**NOTICE OF A REGULAR
PLANNING COMMISSION MEETING
October 14, 2026, at 7:00 PM**

VINEYARD PLANNING COMMISSION STAFF REPORT

Agenda Item: PLAN26-0011 Site Plan Application - Minor Amendment Orchards Phase 7

The applicant is requesting an amendment to the approved site plan for The Orchards Phase 7, affecting Buildings 53 through 64. The proposed modifications include changes to selected unit layouts, Level 2 decks, and storefront colors.

Section 5: Section 15.32.280 “Clear View Triangle On Corner Lots” of the Vineyard Zoning Code is amended as follows:

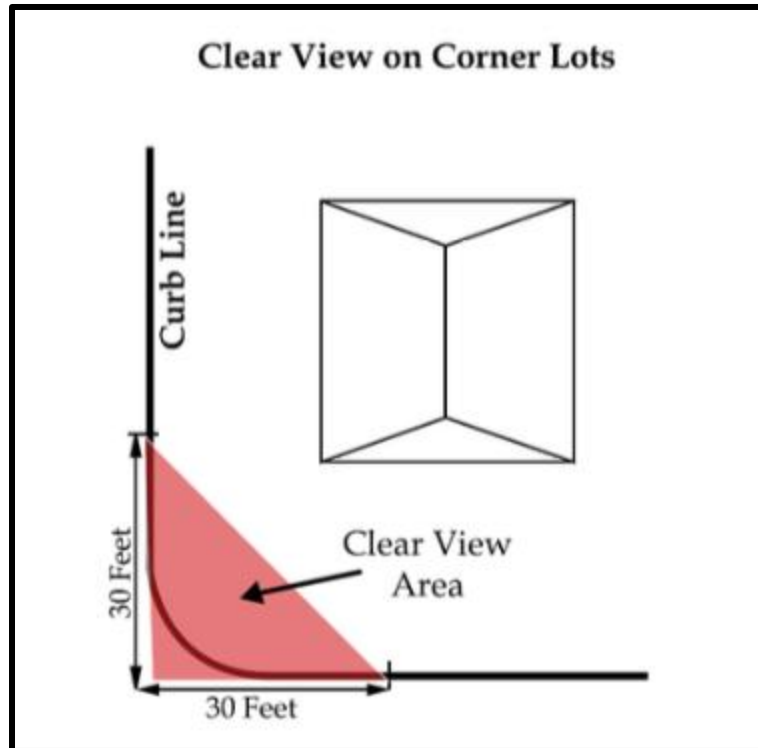
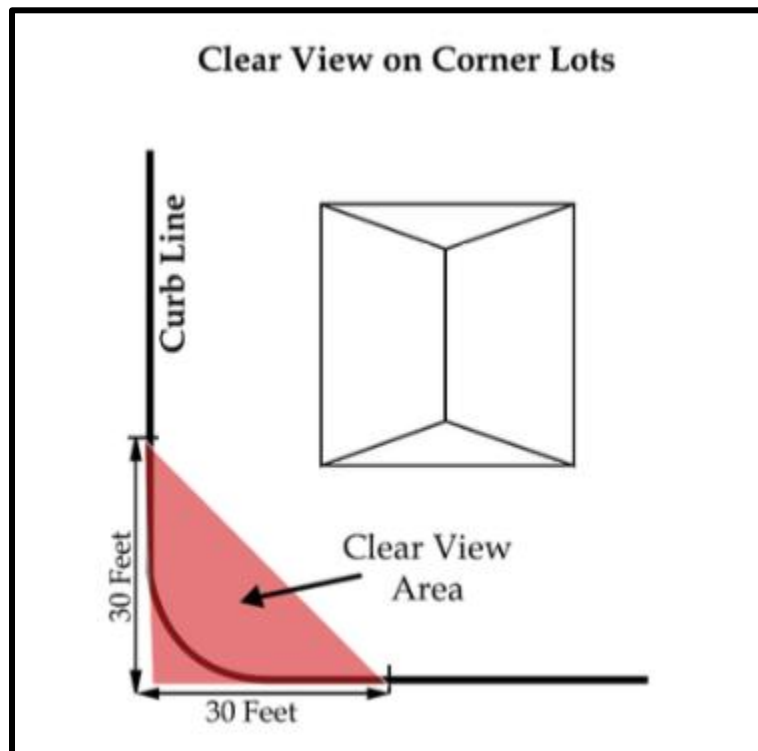
Where two local residential roads intersect within a planned subdivision, no view obstruction including a sight-obscuring fence, wall, sign, other similar structures, and landscaping which exceeds two (2) feet in height shall be placed on any corner lot within a triangular area formed by a diagonal line connecting lines located at the curb line thirty (30) feet from the projected intersection of such curb lines. Where no curb exists, the clear view area shall include that portion of the corner lot lying within a triangular area formed by a diagonal line connecting lines located at the property line twenty (20) feet from the intersection of said property line. Use the Vineyard City Access Management Manual to design sight triangle dimensions for all other intersections.

In all Zoning Districts Where two local residential roads intersect within a planned subdivision, no view obstruction including a sight-obscuring fence, wall, sign, other similar structures, and landscaping which exceeds two (2) feet in height shall be placed on any corner lot within a triangular area formed by a diagonal line connecting lines located at the curb line thirty (30) feet from the projected intersection of such curb lines. Where no curb exists, the clear view area shall include that portion of the corner lot lying within a triangular area formed by a diagonal line connecting lines located at the property line twenty (20) feet from the intersection of said property line. Use the Vineyard City Access Management Manual to design sight triangle dimensions for all other intersections.

Section 6: Section 1.08.040 (S) "Intersection Design" of the Construction and Design Specifications is amended as follows:

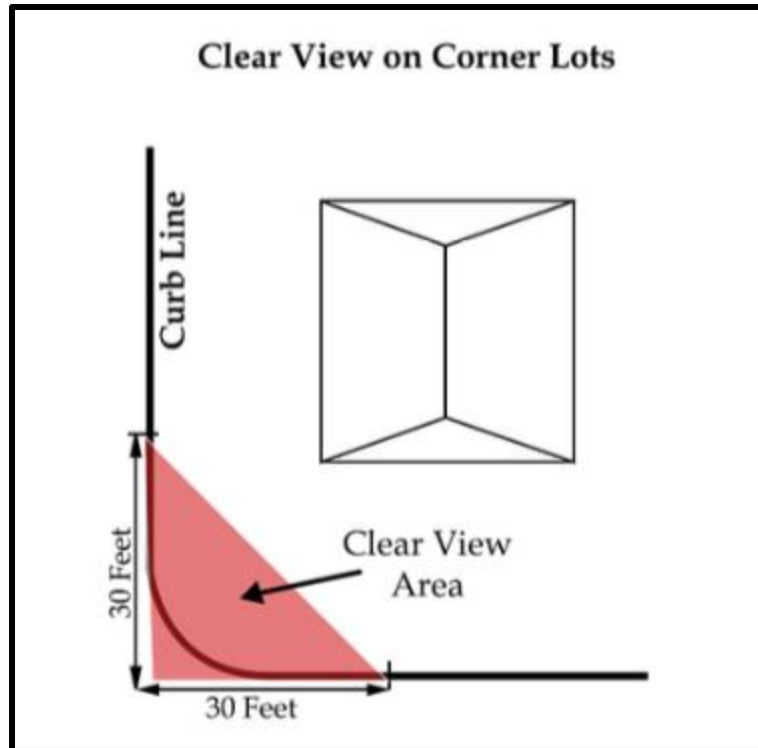
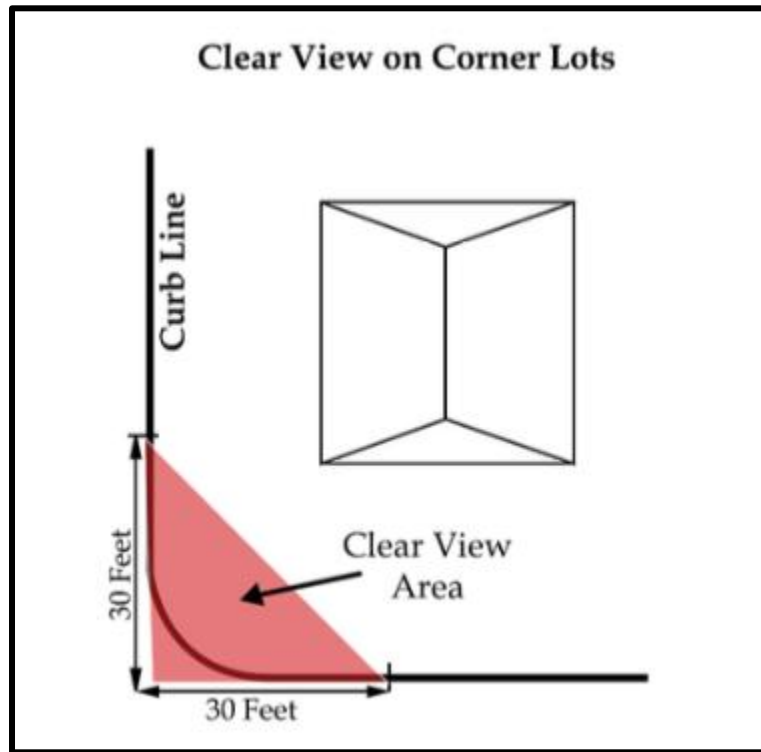
6. Sight Distance Triangle. Where two local residential roads intersect within a planned subdivision, no view obstruction including a sight-obscuring fence, wall, sign, other similar structures, and landscaping which exceeds two (2) feet in height shall be placed on any corner lot within a triangular area formed by a diagonal line connecting lines located at the curb line thirty (30) feet from the projected intersection of such curb lines. Where no curb exists, the clear view area shall include that portion of the corner lot lying within a triangular area formed by a diagonal line connecting lines located at the property line twenty (20) feet from the intersection of said property line. Use the Vineyard City Access Management Manual to design sight triangle dimensions for all other intersections.

6. Sight Distance Triangle. Where two local residential roads intersect within a planned subdivision, no view obstruction including a sight-obscuring fence, wall, sign, other similar structures, and landscaping which exceeds two (2) feet in height shall be placed on any corner lot within a triangular area formed by a diagonal line connecting lines located at the curb line thirty (30) feet from the projected intersection of such curb lines. Where no curb exists, the clear view area shall include that portion of the corner lot lying within a triangular area formed by a diagonal line connecting lines located at the property line twenty (20) feet from the intersection of said property line. Use the Vineyard City Access Management Manual to design sight triangle dimensions for all

~~other intersections. A clear line of sight must be provided at all intersections, see Vineyard City Access Management Manual. The “Sight Distance Triangle” must be calculated using the stopping “Sight Distance” of the road being intersected. The stopping “Sight Distance” is 200 feet for a Local street, 300 feet for a Collector and 425 feet for Arterial. The figure below illustrates the required “Sight Distance Triangle” based on the “Sight Distance”.~~

The Orchards Phase 7: Building 63

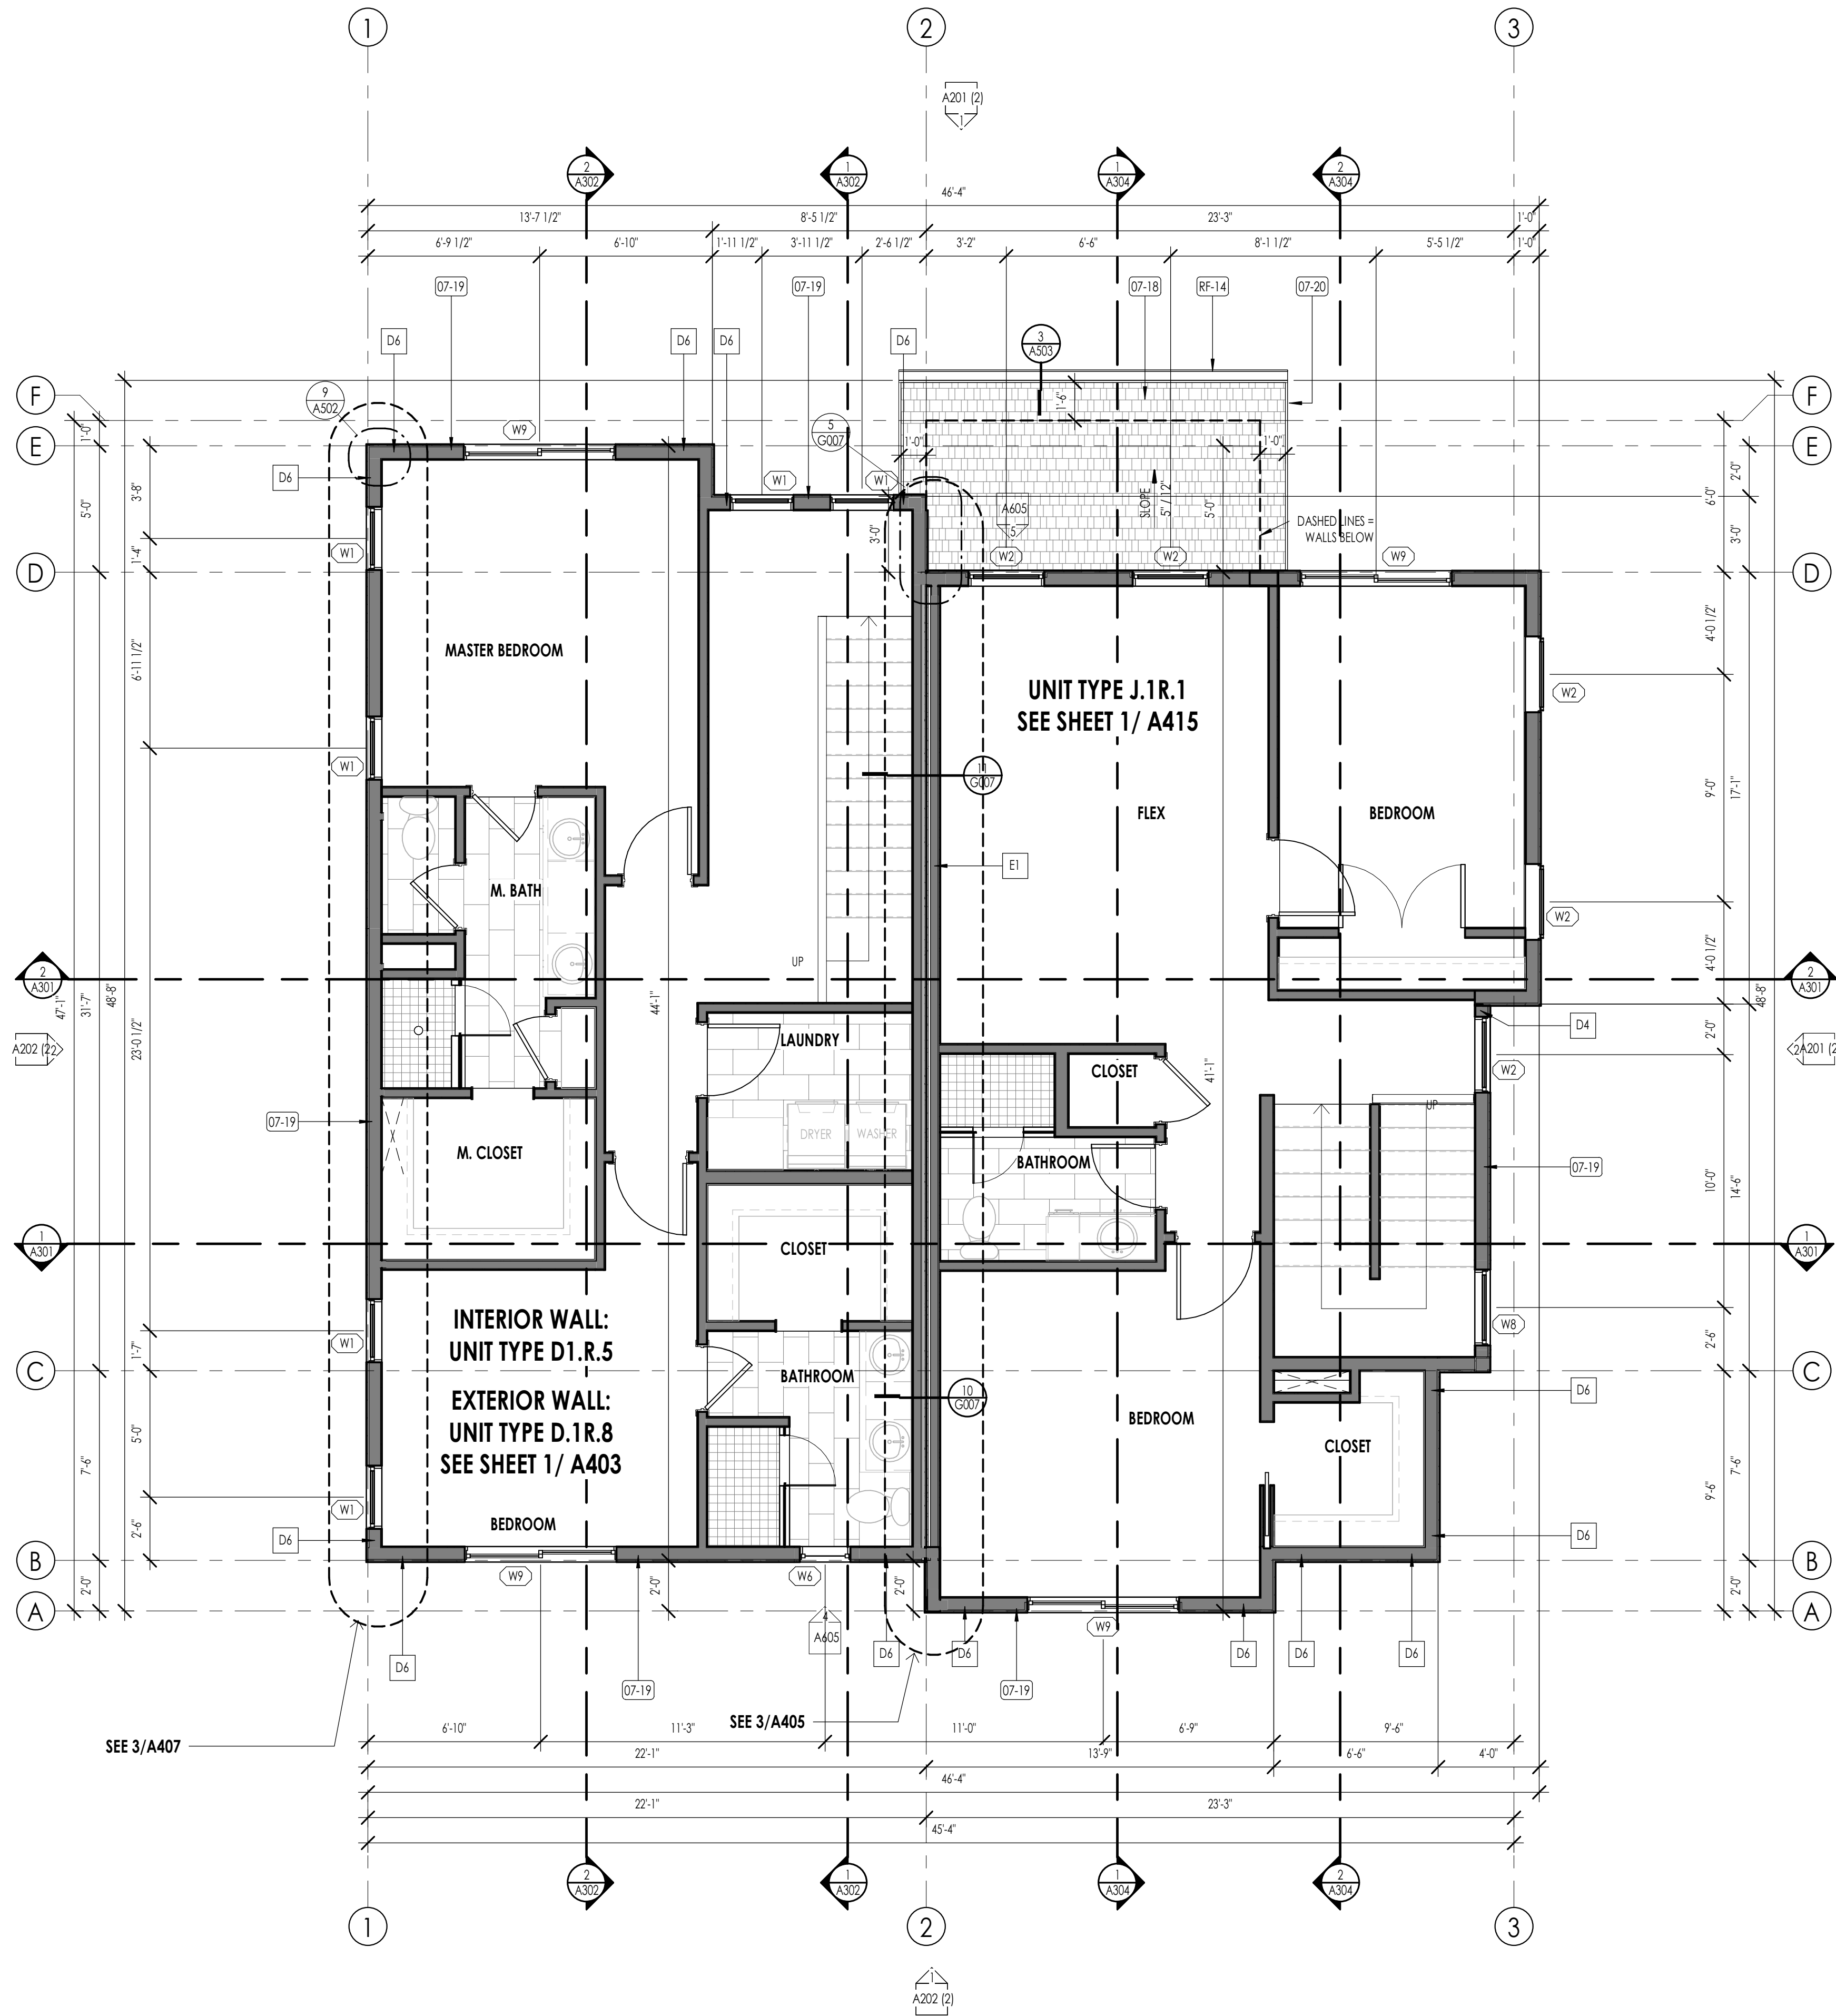
The only items included with Building 54 were the decks at Unit D.

- For Unit Type D, the Level 2 deck has been revised to include a opening in the original brick wall with a railing, providing improved visibility and light to the interior while allowing for more positive deck drainage.
- The storefront color has been changed from dark bronze to white to maintain consistency with the other buildings throughout the development.

LEVEL 3 FLOOR PLAN
1/4" = 1'-0"

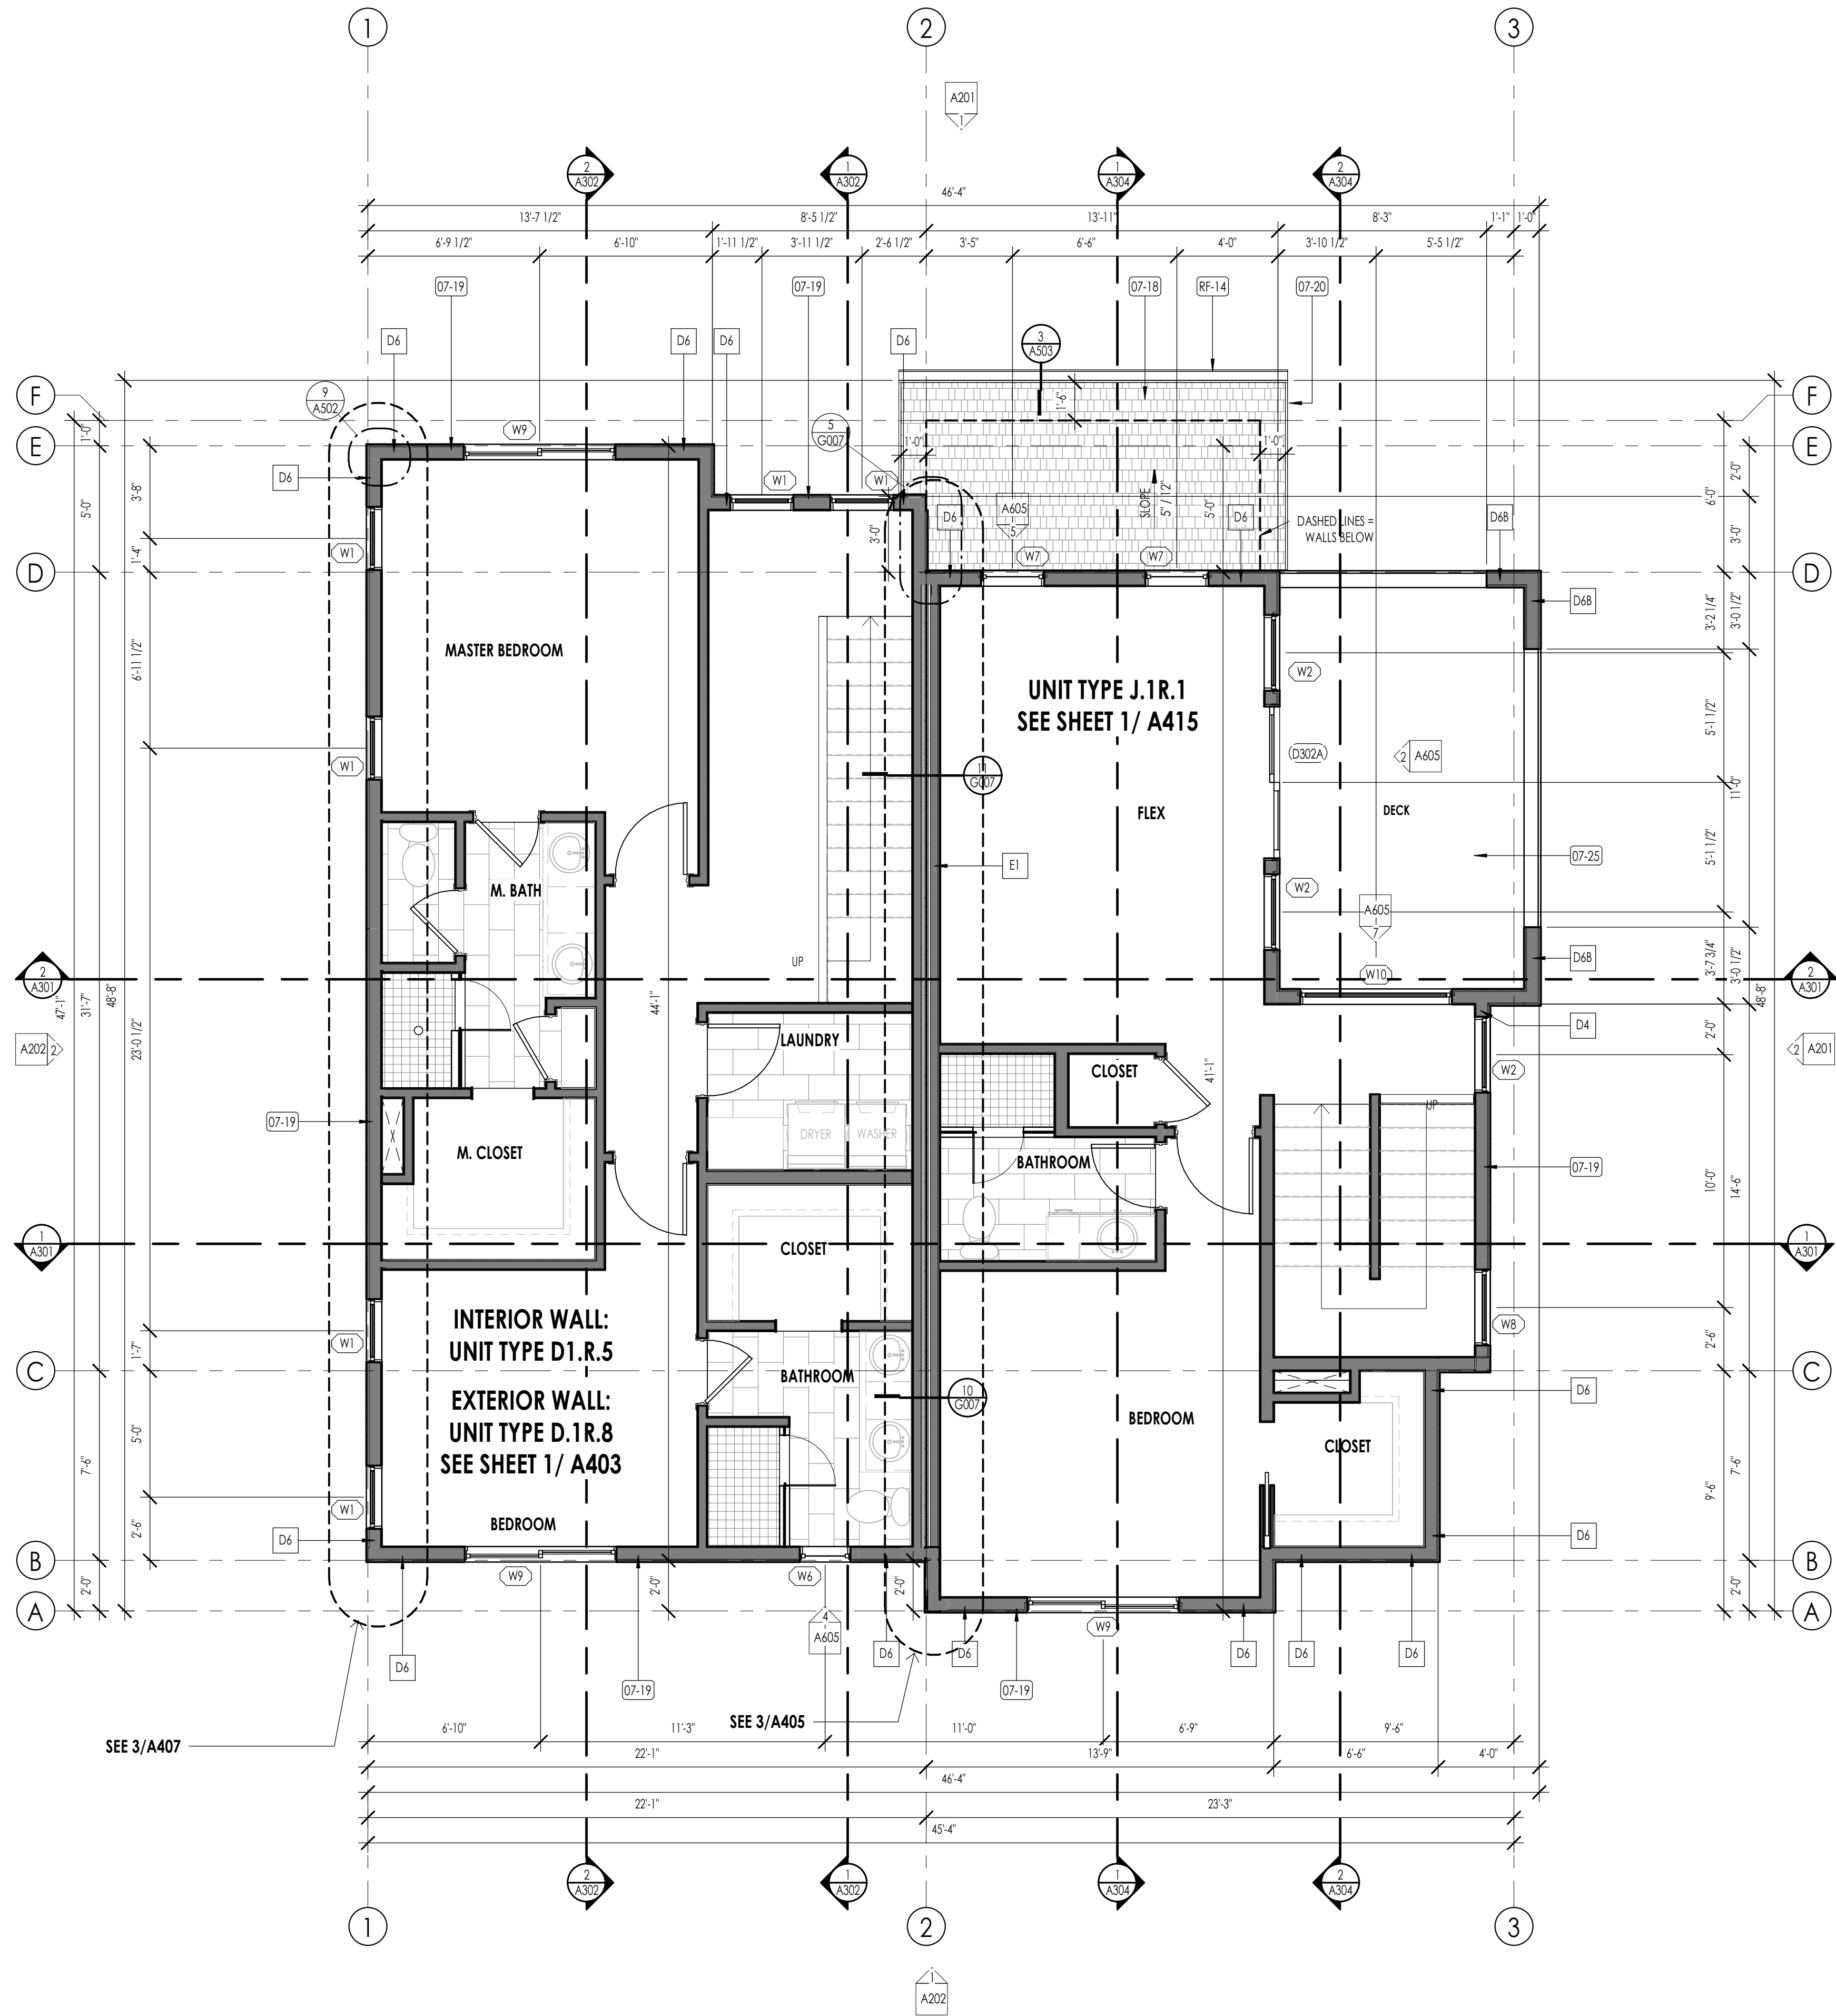
- For Unit Type D, the Level 2 deck has been revised to include a opening in the original brick wall with a railing, providing improved visibility and light to the interior while allowing for more positive deck drainage.
- The storefront color has been changed from dark bronze to white to maintain consistency with the other buildings throughout the development.
